COUNCIL ASSESSMENT REPORT

Panel Reference	PPSSNH-155
DA Number	DA2020/1167
LGA	Northern Beaches Council
Proposed Development	Demolition works and construction of a mixed use development to accommodate a cafe, church, conference centre, boarding house and two level basement car park
Street Address	Part Lot 28 DP 7413, 9 Francis Street and 28 Fisher Road, Dee Why
Applicant/Owner	Baptist Churches of NSW Property Trust (Owner) The George Group Pty Ltd (Applicant)
Date of DA lodgement	22 September 2020
Number of Submissions	38 submissions which includes: <ul style="list-style-type: none"> • 16 submissions in support; • 22 submissions in opposition
Recommendation	Refusal
Regional Development Criteria (Schedule 7 of the SEPP (State and Regional Development) 2011)	Development with a Capital Investment Value (CIV) of more than \$5 million for affordable housing (which includes a Boarding House)
List of all relevant s4.15(1)(a) matters	<ul style="list-style-type: none"> • Environmental Planning and Assessment Act 1979 • Environmental Planning and Assessment Regulation 2000 • State Environmental Planning Policy No. 55 – Remediation of Land • State Environmental Planning Policy (Building Sust

Figure 7 North Elevation (Source: The Georges Group Pty Ltd)

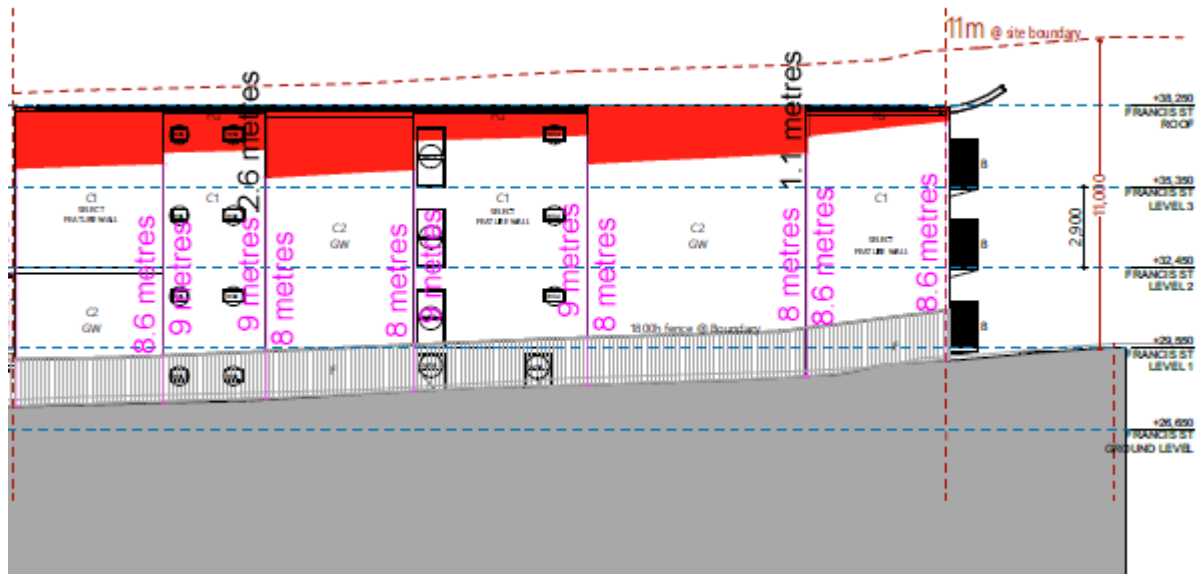
- North - 32.5% - 13.8%
- South - 50% - 26.7%

The variation extends for the length of the western building as depicted in the following figures:

The development fails to provide any increased separation as the building envelope has increased. While this would not provide any additional relief at ground level, it will certainly provide a greater sense of openness and separation from the adjoining properties.
